DEVELOPMENT REVIEW COMMITTEE (DRC) COMMENT REPORT

PROJECT NAME: Avery – Cypress Creek

CASE NUMBER: UDP-S22017

REQUEST: Site Plan Level III Review: Conditional Use for Building Height Exceeding 75 Feet, Allocation of 200 Residential Flex Units Inclusive of 24 Affordable Housing Units, and 5,000 Square-Foot of Commercial Use with an Associated Parking Reduction in the Uptown Project Area

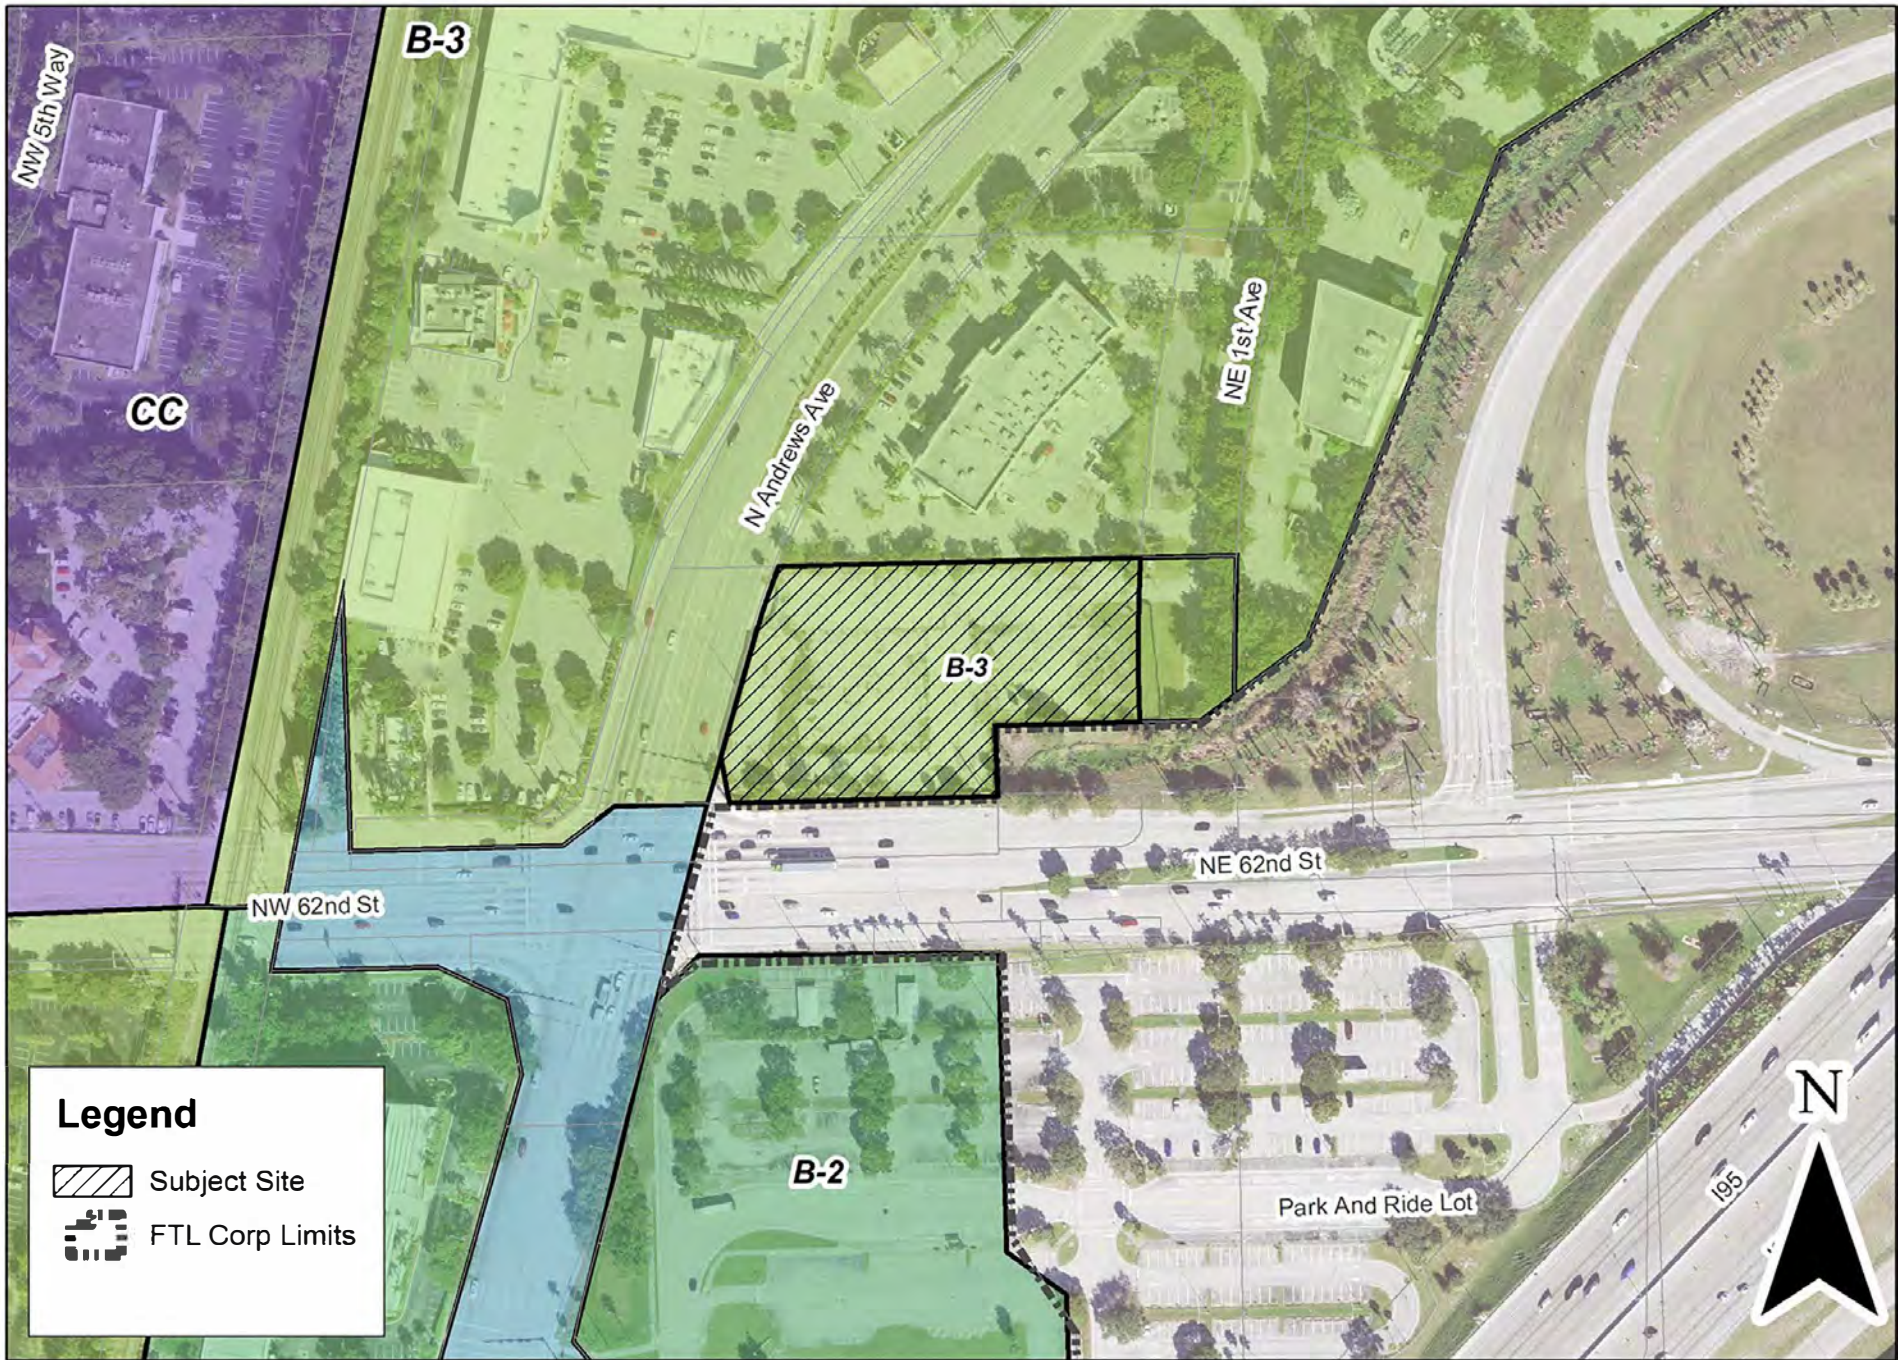
- d. Pursuant to ULDR, Section 47-37B.6.I, Streetscape, as proposed, it does not appear the streetscapes meet the requirements of this section. Provide detailed cross sections for Cypress Creek Road and Andrews Avenue, depicting the streetscape zones in relation to the building frontage. Refer to image below.
